PLANNING AND ZONING COMMISSION MEMORANDUM

FROM: Planning & Zoning Department **DATE:** May 21, 2020
SUBJECT: SUP 2020-03 Public hearing and consideration of a request from Dominique Van Ausdall for a revised special use permit for a brewpub at 7924 Maplewood Avenue, being 0.8 acres described as Lots 2R and 6, Block 23, Clear View Addition.
PRESENTER: Clayton Comstock, Planning Director

Development Review Committee Recommendation for Site and Building Improvements

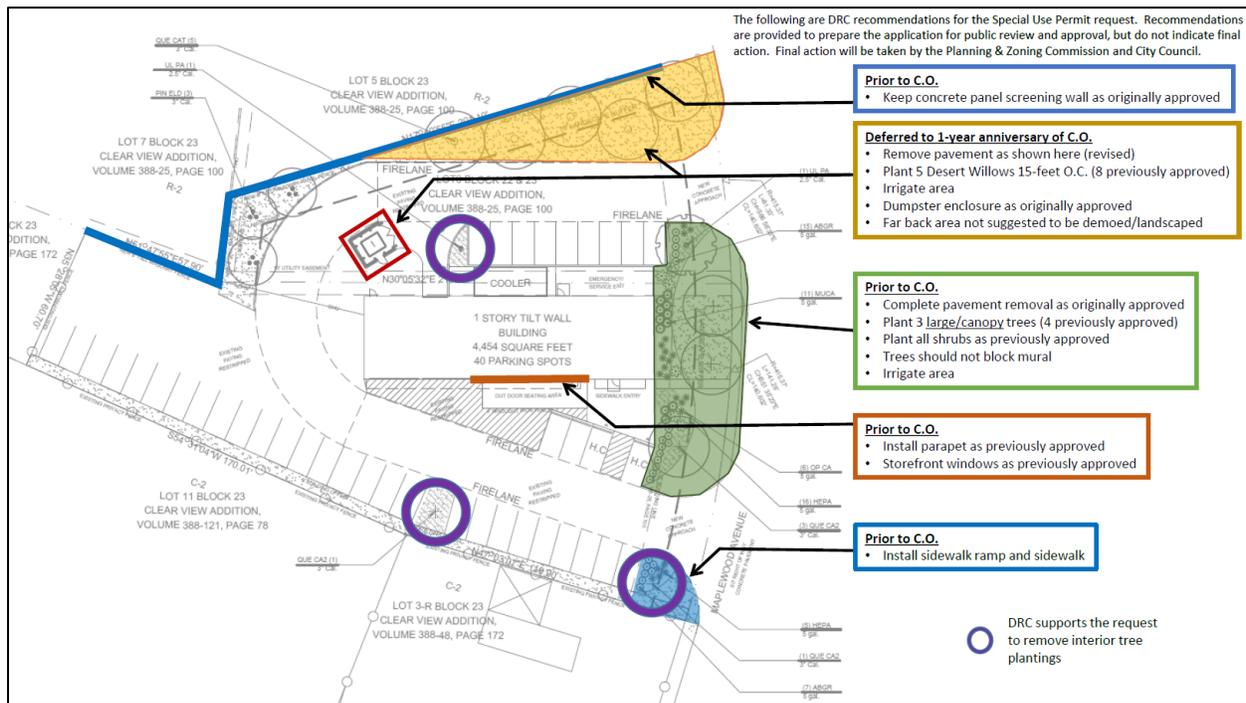
Since the deferral to complete some site improvements was included in the original SUP approval, the DRC supports a phased approach for the revised proposal. However, the DRC recommends that the time frames be modified so that most improvements are made prior to the issuance of a certificate of occupancy, with other improvements being completed within one year of issuance. The table and graphic below summarizes the DRC recommendation.

TIMEFRAME	DRC PROPOSAL
Prior to Certificate of Occupancy	<ul style="list-style-type: none"> 6-foot masonry screening wall and all exterior building improvements, pavement removal and landscaping unless otherwise described below.
Deferred to 1-Year after C.O.	<ul style="list-style-type: none"> Pavement removal, irrigation and landscaping of west property line (yellow below) and the dumpster enclosure
